**Federal Highway
Administration**

Refer to: HNG-14

This is to summarize the results of several contacts you and your consultant, Dr. Ahomad Ahmadi, have had with Mr. Benjamin Tang and Mr. James H. Hatton, Jr., of the Federal Highway Administration, Office of Engineering, regarding the acceptability of proposed details for mounting a shaped concrete parapet on a grid reinforced concrete bridge deck. The principal issue under consideration was the adequacy of the anchorage of the "Z" bar connecting the parapet to the deck. The finite element analysis supplied with your September 8 letter to Mr. Hatton dispelled our concerns on that issue. Therefore, the parapet attachment detail shown in the enclosed drawing, which was forwarded with your November 3 letter to Mr. Hatton, is satisfactory, subject to the comments below, and acceptable for use on the National Highway System projects if proposed by a State highway agency.

TYPICAL ATTACHMENT OF CONCRETE PARAPET TO GRID REINFORCED CONCRETE BRIDGE DECK

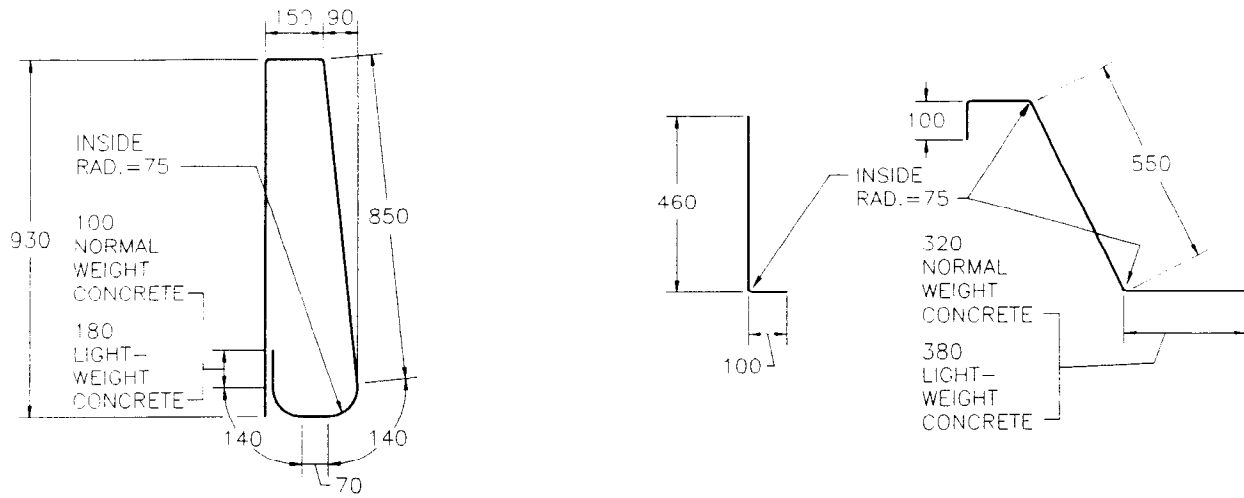
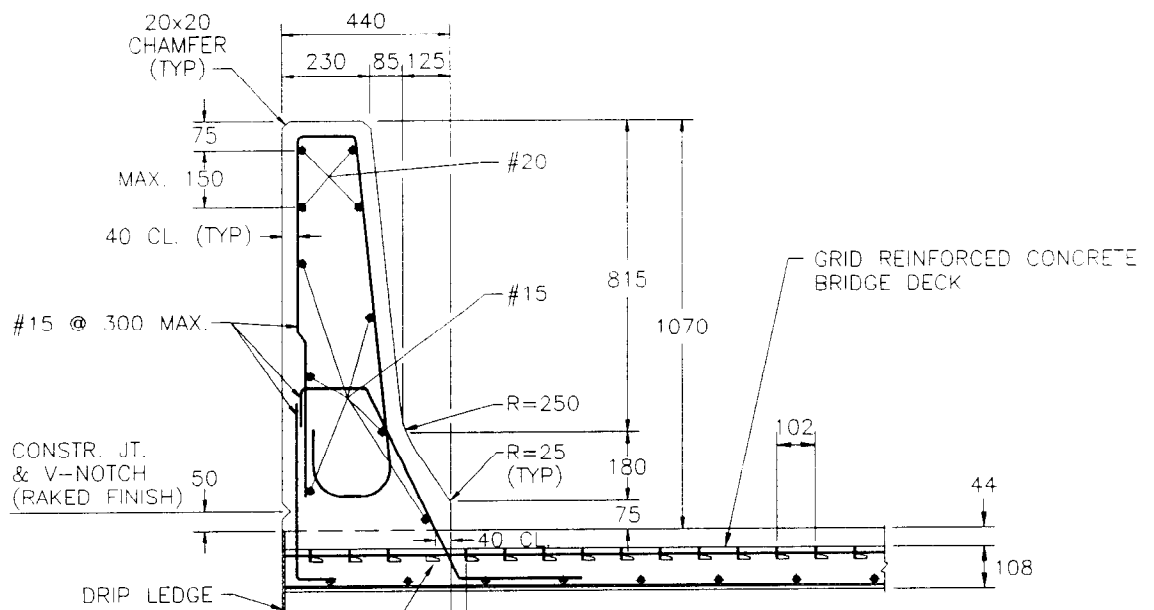
- o The quantity of steel, both vertical and longitudinal in the parapet is less than that used in a comparable crash-tested parapet. However, given that the base of the parapet is wider in the detail you supplied than was the base in the tested parapet and that the tested parapet was not damaged by the testing, we would not insist upon an increase in the reinforcement except as indicated in the next comment.

- o In an earlier drawing you provided there was a note that read, "within 4200 mm on both sides of an [open] joint in the parapet...and at the end of the bridge, reduce maximum spacing of vertical reinforcement to half the shown spacing." While we consider the length along the parapet over which the reduced spacing of the vertical reinforcement applies to be somewhat conservative, in view of the previous comment, the reduced spacing requirement should be added to the drawing supplied with your November 3 letter.

- o An important factor revealed by the finite element analysis was that the toe of the "Z" bar is below the neutral axis of the bridge deck. A special provision should be developed to ensure that the lower horizontal portion of the "Z" bar, the toe, will, with proper consideration for cover, be placed as low in the grid reinforced deck as permitted by the grid to ensure that the toe will always be below the neutral axis of the deck.

- o In the finite element analysis, good shear transfer at the interface between the bottom of the parapet and the top of the deck was assumed. The construction specifications should ensure that the contact surface on the deck is properly cleaned and prepared prior to placement of the parapet concrete to ensure proper performance.
